THE CITY OF WALTHAM
MASSACHUSETTS

Light Dimmer System, Waltham High School

ADDENDUM NO. 1

May 12, 2014

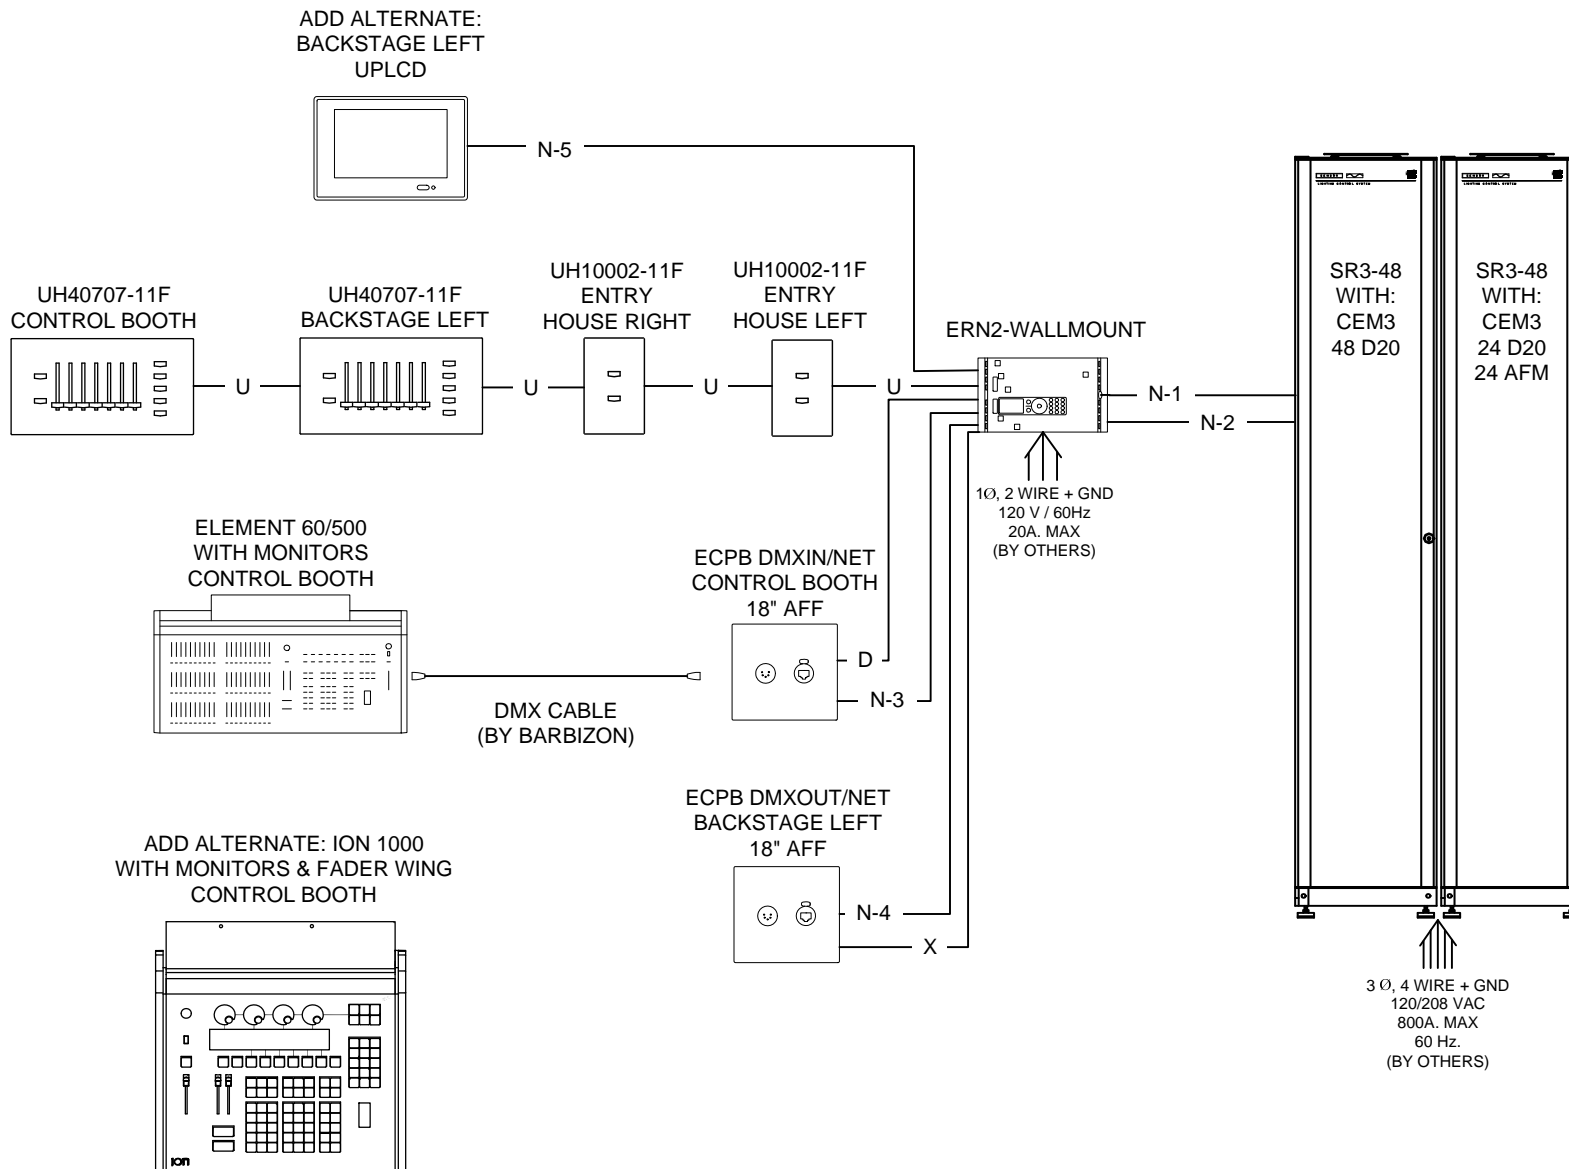
Q9. IS A RISER DIAGRAM AVAILABLE?

A9. SEE ATTACHED
